MILLS FAMILY DIVISION SUBDIVISION

APPLICATION NUMBER 5 DATE September 4, 2014

DETAIL SITE PLAN

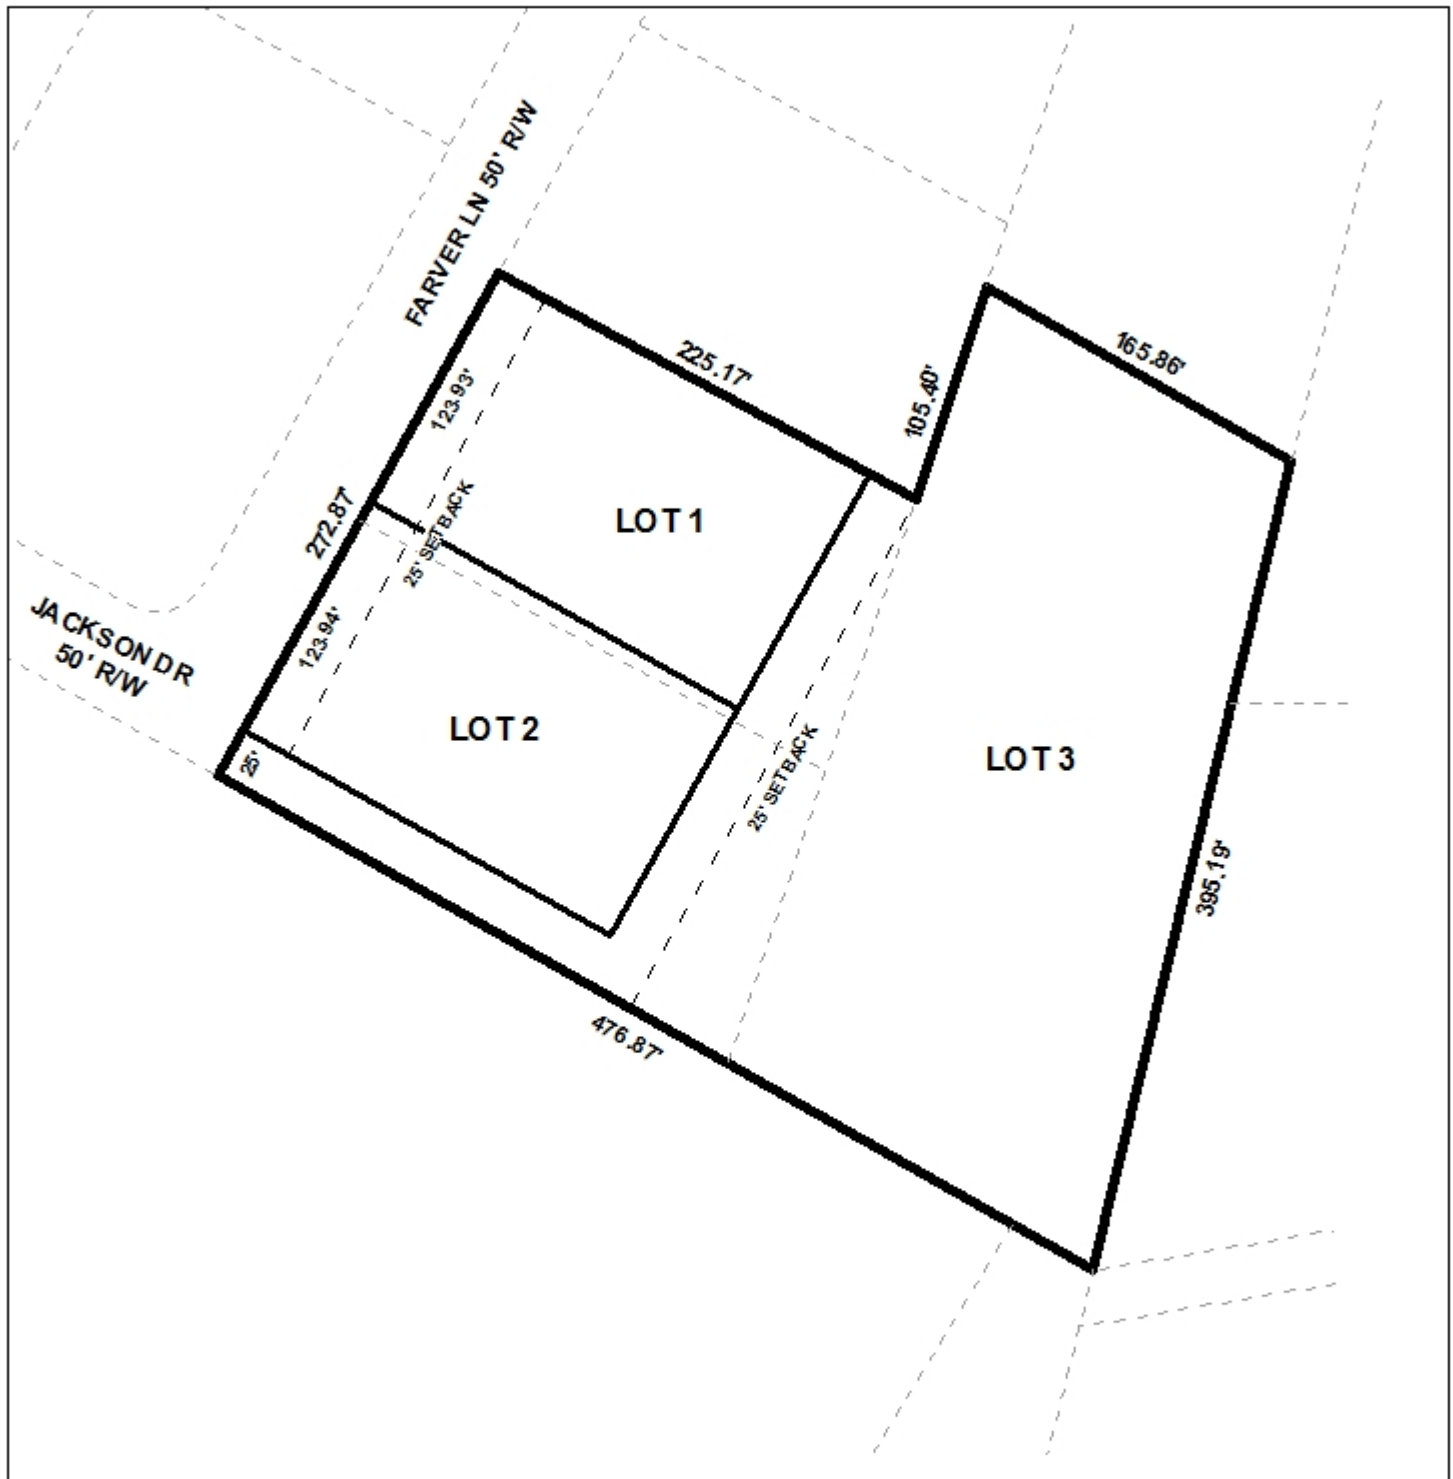
The proposed lots have frontage along Farver Lane, a minor street without curb and gutter. The preliminary plat submitted indicates that Farver Lane has a current 50' right-of-way. A 60' right-of-way would normally be required for a street without curb and gutter; however, Lots 1 and 2 are apart of the previously recorded Sherbrook Subdivision with an approved 50' right-of-way. Thus no dedication should be required.

The 25' minimum building setback is shown on the plat, and should be placed on the Final Plat, if approved.

As proposed, Lot 3 will be a "flag" lot which is generally discouraged by Section V.D.1. of the Subdivision Regulations. However, they are permitted in those locations where varied and irregularly-shaped lot designs are common, a family division of property, or if the informality of design is consistent with other lots in the vicinity. The applicant has submitted a letter stating the proposed 3 lots will be a family subdivision, which is an additional criteria regarding flag lot requests. There have been several other flag lots allowed by the Planning Commission on Hollingers Island, and this particular subdivision would be similar to others in the vicinity. A waiver of Sections V.D.1. of the Subdivision Regulations will be required. A note should also be placed on the Final Plat stating that no further resubdivision of Lot 3 will be allowed until additional public street frontage is provided.

As a means of access management, a note should be placed on the Final Plat stating that each lot is limited to one curb cut to Farver Lane, with the size, location and design to be approved by County Engineering and conform to AASHTO standards.

As on the preliminary plat, the lots should be labeled with the sizes in square feet and acres on the Final Plat, or a table should be furnished providing the same information, if approved.

It should be noted that the applicant has stated that public water and sanitary sewer is provided; however, comments received from the Mobile Area Water and Sewer System indicate that there is **no** water and sanitary sewer service available at this location. Any proposed lot(s) where there is no public water and sanitary sewer services provided must be a minimum of 40,000 square feet as required by Section V.D.2 of the Subdivision Regulations. Thus Lot 1 and 2 would not meet the minimum size requirements as proposed. This application should be heldover until the October 2nd meeting to allow the discrepancy to be resolved.

RECOMMENDATIONS Based upon the preceding, the application is recommended for Holdover until the October 2, 2014 meeting, with revisions due by September 10, 2014 to address the following:

1. documentation should be provided to indicate if the site is connected to public or private water and sanitary sewer.
